City of Napoleon, Ohio

Re: 655 Trail Drive Sewer Connection

655 Trail Dr. 6-04-2015

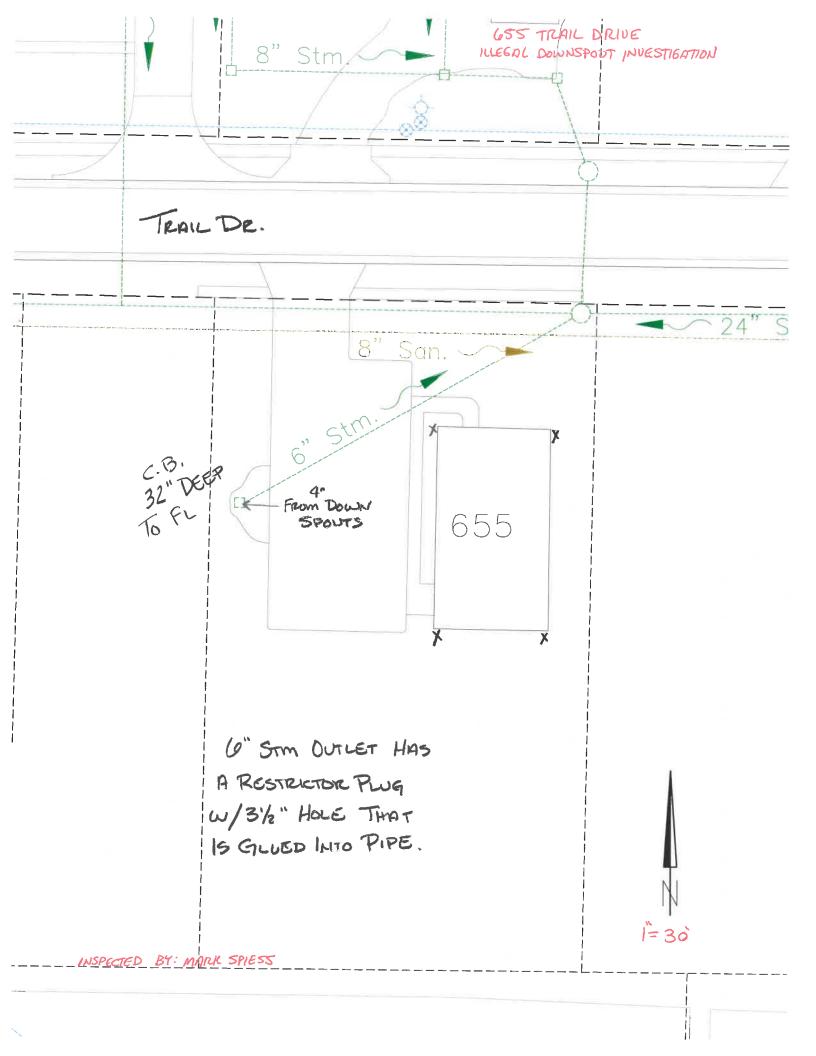
After receiving a letter dated 5-26-2015 giving two options to address the sewer issues at 655 Trail Dr., Dr. Parsell attempted to complete Option 1. He then called to explain that Option 1 was more labor intensive than anticipated and since the downspout on the northwest corner would have to stay connected anyway, he decided to try Option 2. In an effort to reduce cost and save time, he asked if restrictor plug could be put in the end of the out let pipe instead of the restrictor plate. Upon further discussion with the Director Of Public Works about the configuration of the pipes in the structure, it was agreed to use a restrictor plug with at 3 ½" hole. The end of the pipe was inspected to make sure the rubber gasket was still in place. Using PVC glue, Dr. Parsell then glued the plug into the bell end of the pipe. See attached picture.
